MEMO

To: Zach Mosher, City of Auburn Planner
From: Christopher Michaud, P.E., Project Engineer

RE: **Peer Review Response of Danville Road Subdivision | Auburn, Maine**

The comment provided by Woodard & Curran is shown in italics, followed by the response from CES in bold.

C700

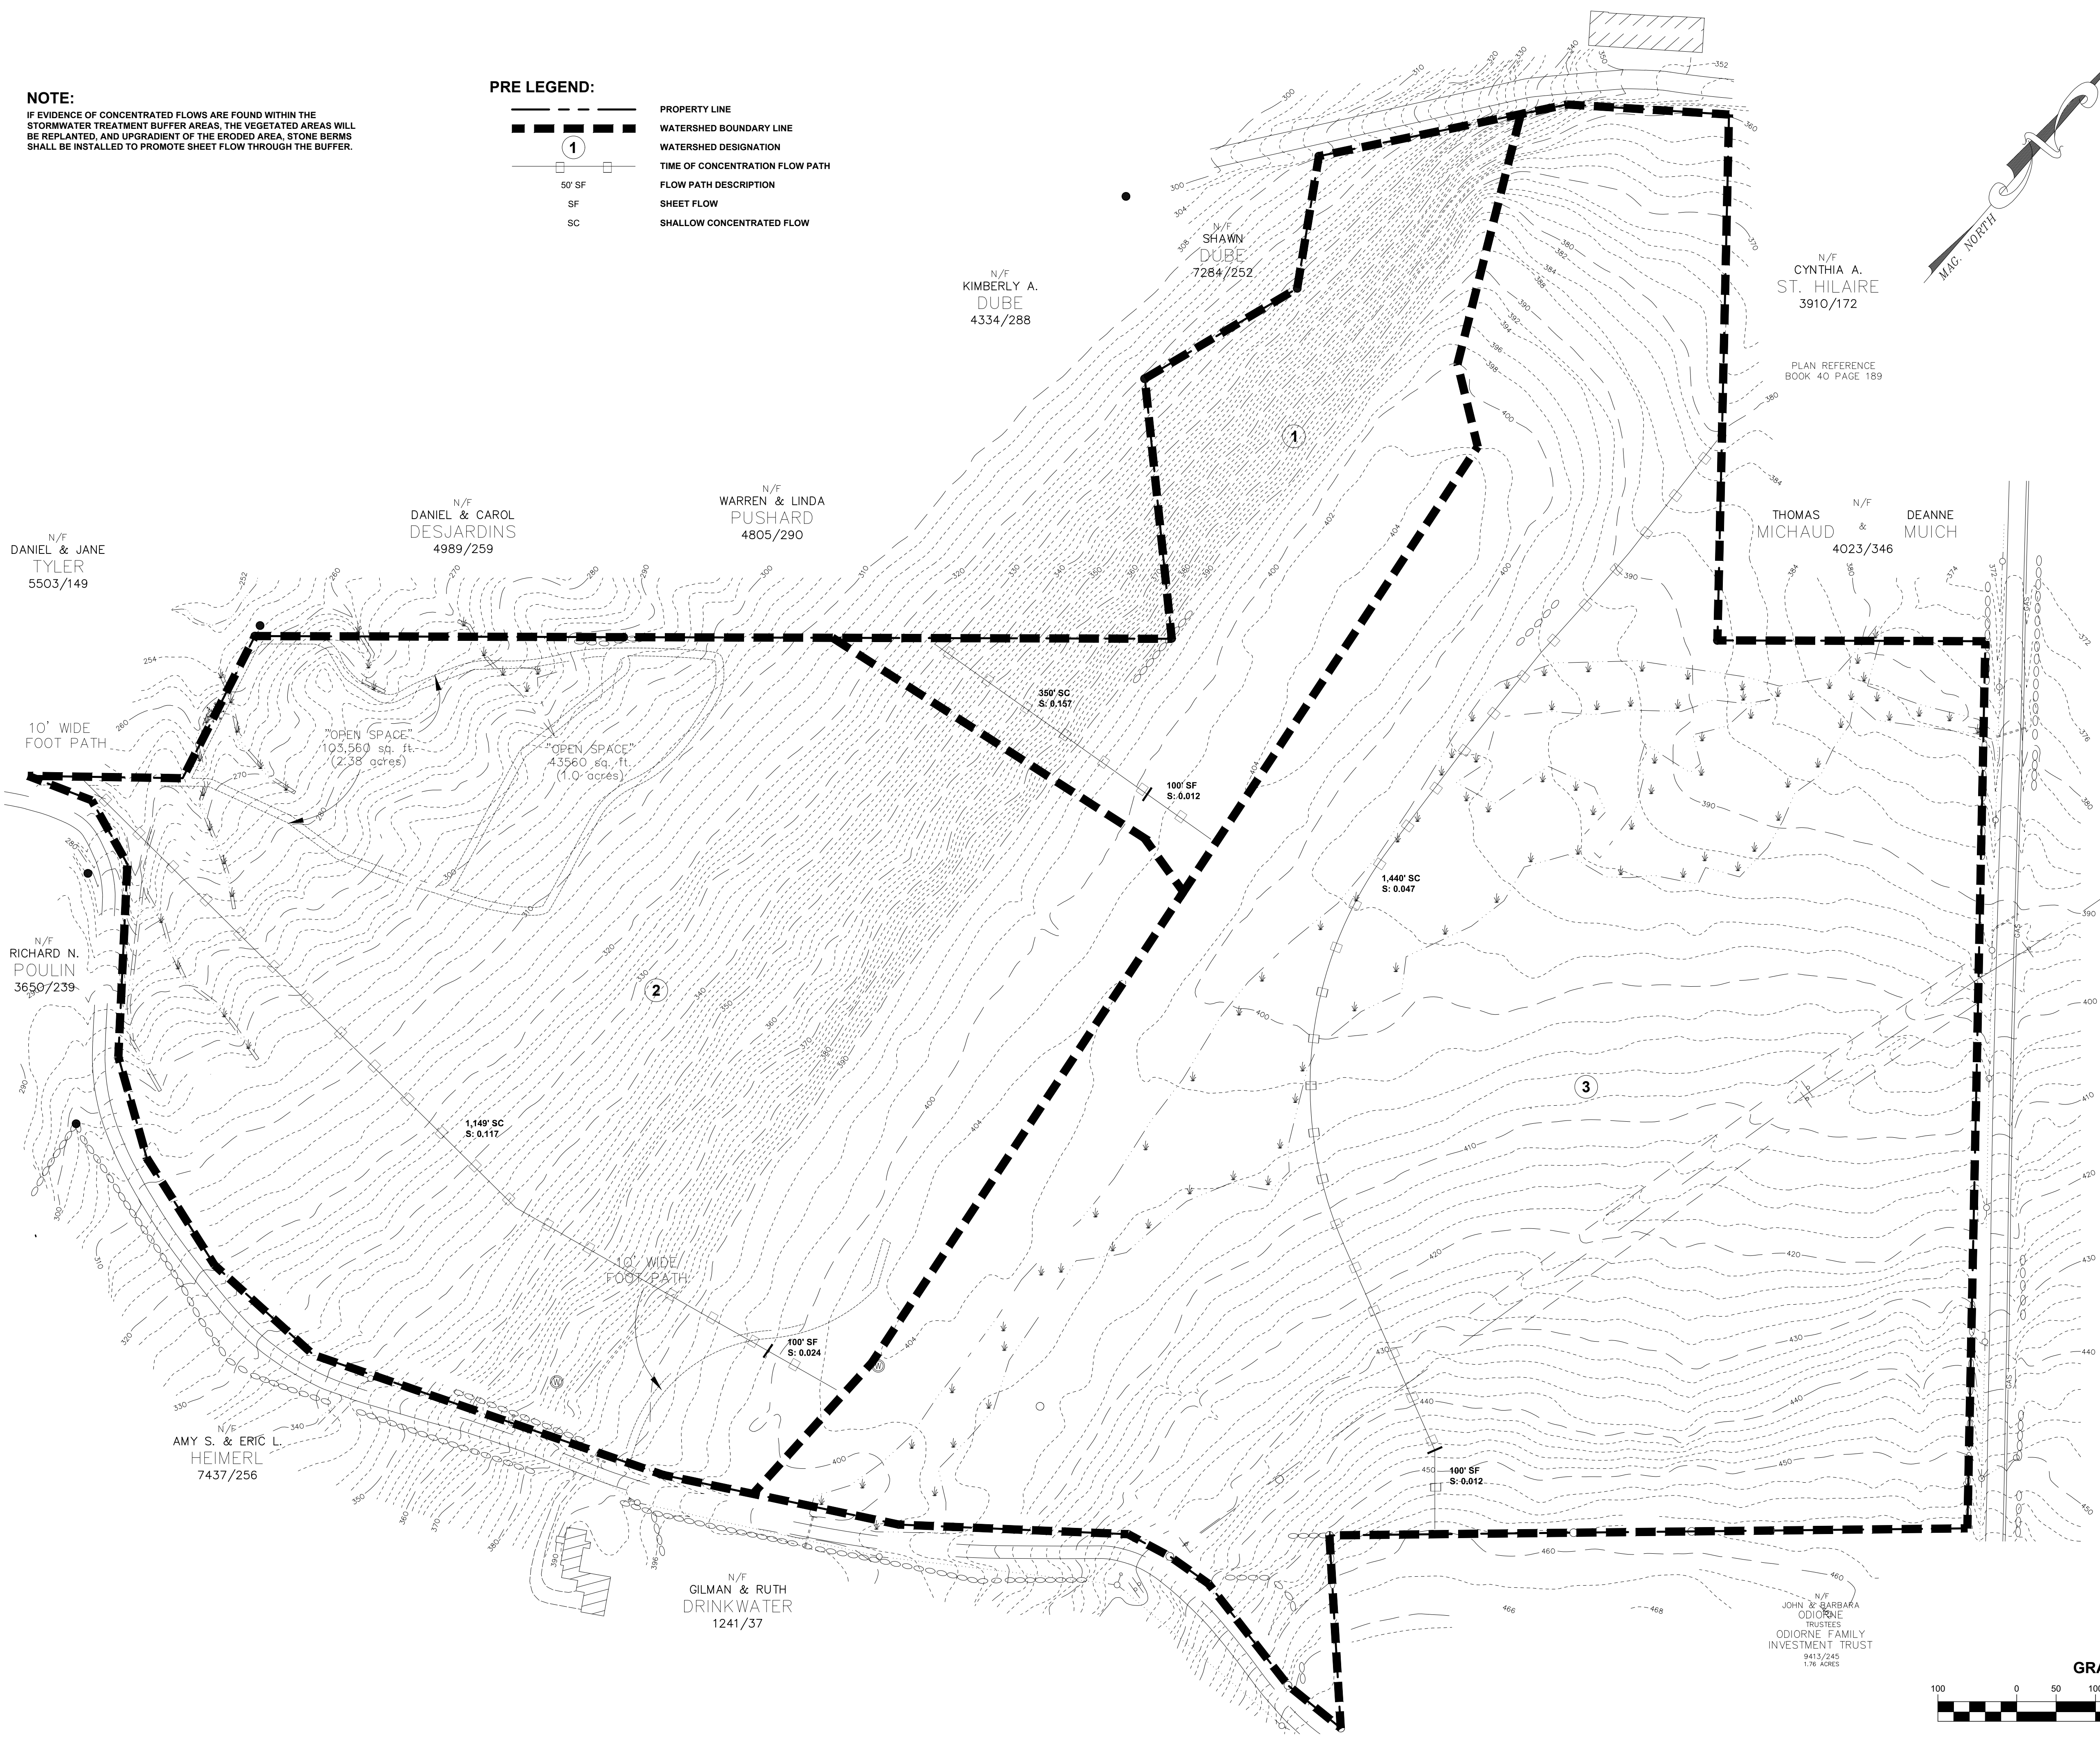
It appears that the Applicant is proposing Buffers along the frontage of several residential lots, such as Lots 3, 12, 21, and 22. The Applicant should clarify how access will be provided to these lots without disturbing the proposed Buffer areas, and provide plans showing the locations of all proposed driveway entrances.

The Post-Development Stormwater Plan notes that the area of subcatchments 2 and 4 shall be “regarded” such that the flow is towards Skyline Drive; however, the provided topography indicates that runoff will flow away from Skyline Drive. The Applicant should clarify whether this area is intended to be “re-graded” and provide an appropriate Grading Plan that shows the proposed contours. Additionally, the Applicant should clarify how Biocell 3 discharges to Summation Point 1, and how Biocell 1 and 2 discharge to Summation Point 2 and provide an appropriate drainage plan that shows all proposed drainage infrastructure.

Aerial photography shows that the entrance to Lot 3 intersects Danville Corner Road. The driveway to Lot 12 is proposed on the upgradient side of the proposed buffer and is not expected to interfere with the buffer's location. A section of buffer has been removed as a part of the revised Stormwater Management Plan to account for intersecting driveways to Lots 21 and 22. Please see Sheet C700.

The flow path to proposed bioretention filter basins will be grassed lawns or grassed ditches to mitigate the discharge of sediment to basin entrances. A note with this statement has been added to Sheet C700. Additionally, a requirement for stone check dams as biocell entrances has been noted on Sheet C700. A more detailed design of bioretention cells and supporting check dams can be provided with the preparation of construction documents.

Detailed grading of this area has been provided as a part of this revision. Please see attached Sheet C700.

UNDERDRAIN LAYOUT

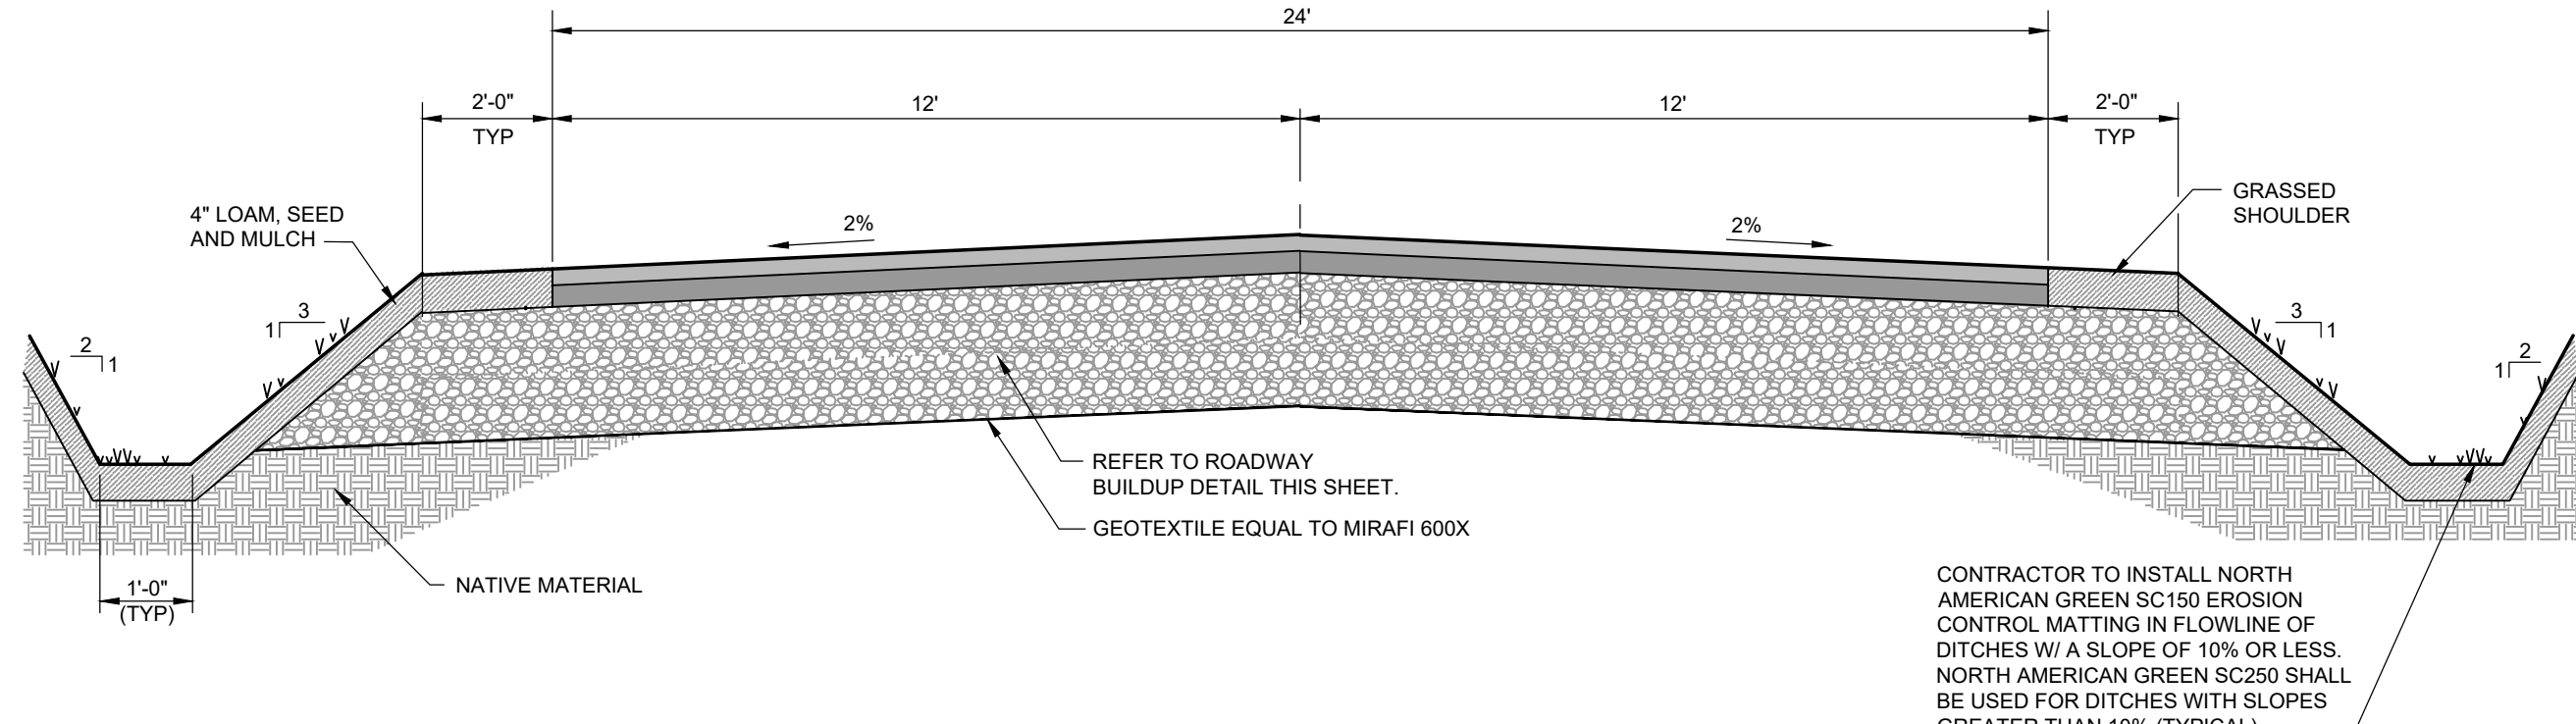
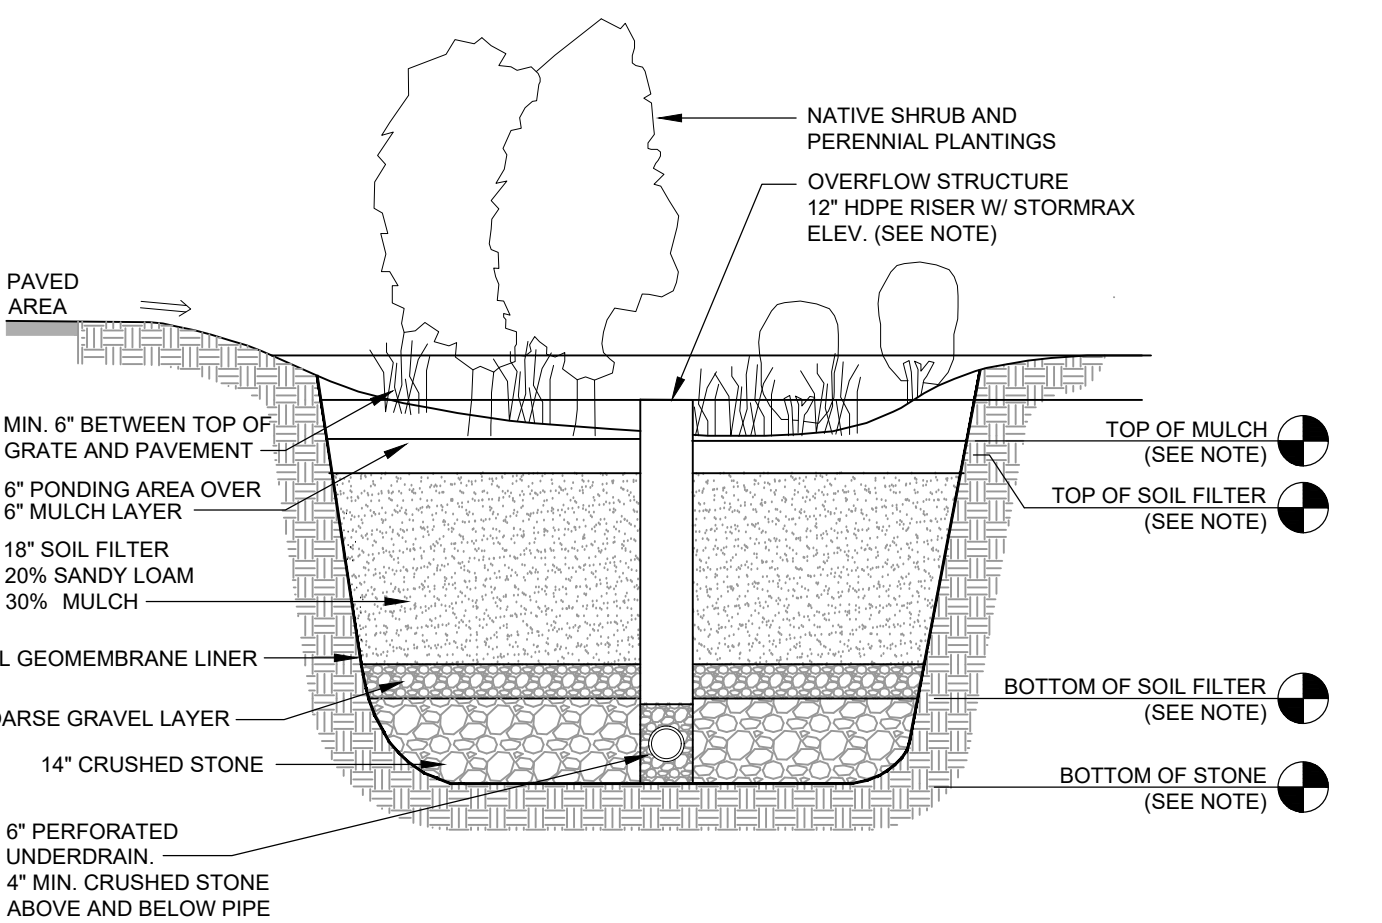
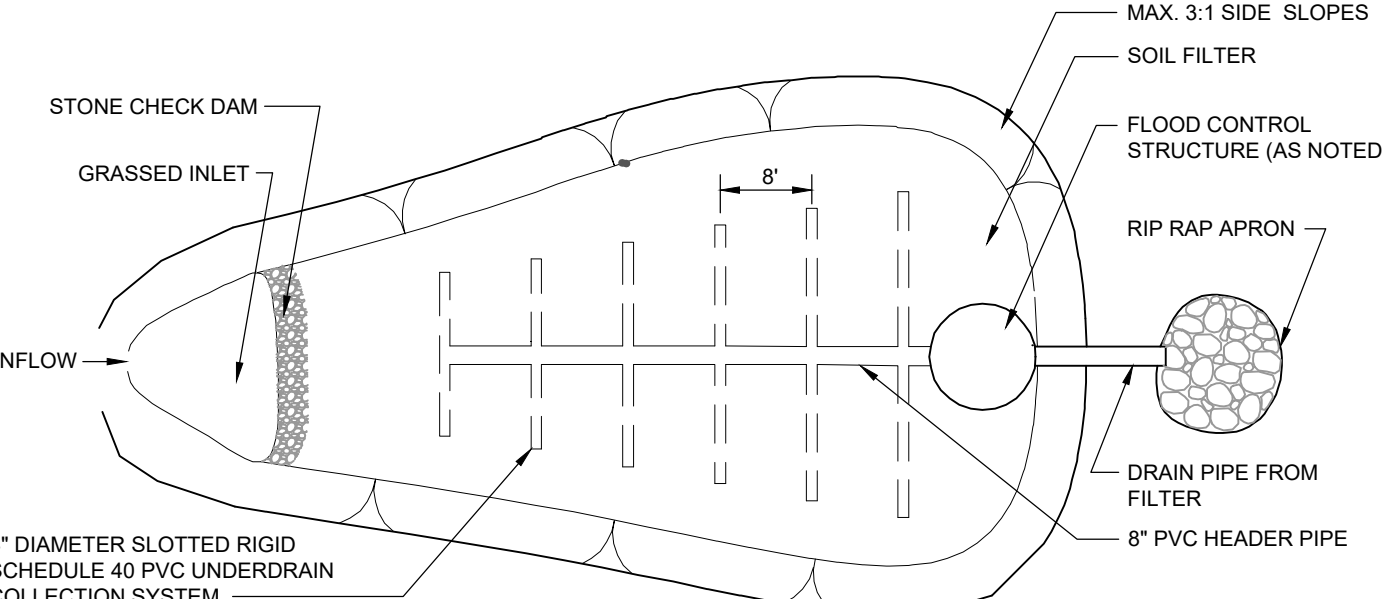
The Bioretention Cell Detail shall be updated to specify underdrain bedding equal to MaineDOT 703.22 Type B material, or alternatively, a 6-inch coarse gravel layer should be added above the crushed stone underdrain bedding.

The soil filter surface should be planted with plants that are tolerant of well drained soils and frequent inundation. Native plants should be chosen for their tolerance to urban runoff, moisture fluctuation, pollutant loading, light amount, temperature and ph. Based upon the expected full-grown size of the plant, the plants' spacing should be no more than 18 inches to 3 feet on center. A landscape planting plan should be provided for each bioretention cell.

A proper layout of the pipe underdrain system is necessary to effectively drain the entire filter area. The pipes should be spaced no further than 15 feet apart and should have a positive gradient. More detailed design plans of the proposed bioretention cells showing the underdrain layout should be provided.

At least 4 inches of material should be provided above and beneath the underdrain pipe; the bioretention cell detail should be revised to specify this requirement.

The 18" Mulch Layer in the bioretention cell detail should be revised to comply with the Soil Filter Bed material requirements.

It is unclear what the flood elevation and emergency spillway provisions of the bioretention cells are. The Applicant should clarify and provide more detailed plans of the proposed bioretention cells.

The Bioretention Cell detail on Sheet C501 has been updated to include a 6-inch layer of coarse gravel above the crushed stone underdrain bedding.

A note has been added to the Bioretention Cell Detail on Sheet C501 that proposed plantings shall be in accordance with MDEP Storm Management BMP's.

Please refer to Bioretention Cell Detail on Detail Sheet C501 where a note identifying underdrain pipe spacing has been included. Based on previous projects permitted through the City of Auburn, a detailed design for bioretention cells has not been required at the time of permit application submission. More detailed design information can be provided through the construction design process.

The previously submitted bioretention cell detail has been updated to identify 4-inches of material above and below proposed underdrain pipes.

The Bioretention Cell Details has been revised to reflect the most recent MDEP Bioretention Cell detail.

An overflow structure has been proposed for each bioretention cell. Overflow structure elevations can be found in the Bioretention Cell Elevations Table on Sheet C501. Based on projects previously permitted through the City of Auburn, a more detailed design can be provided with the preparation of construction design documents.
